**R44 SERVICE BULLETIN SB-88**

**DATE:** 8 December 2014

**SUBJECT:** Landing Gear Attach Nuts

**ROTORCRAFT AFFECTED:** R44 helicopters S/N 2353 thru 2374 and R44 II helicopters S/N 13661 thru 13747.

**FIGURE 1**

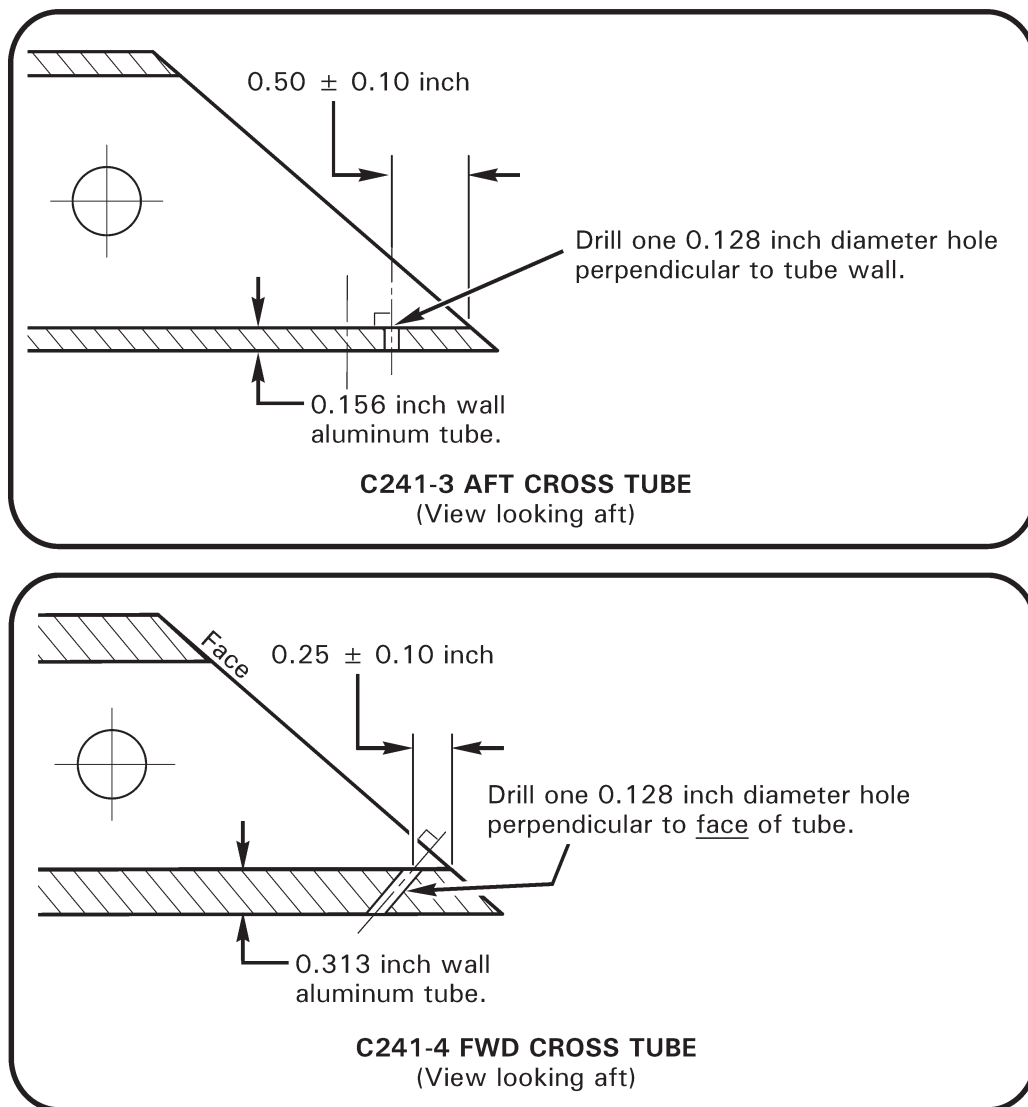
5. Refer to Figure 1. Lay out vent hole location on left side of C241-3 (aft) cross tube and left side of C241-4 (forward) cross tube as shown. Drill one 0.128 inch diameter hole in each cross tube and deburr. Clean up debris.
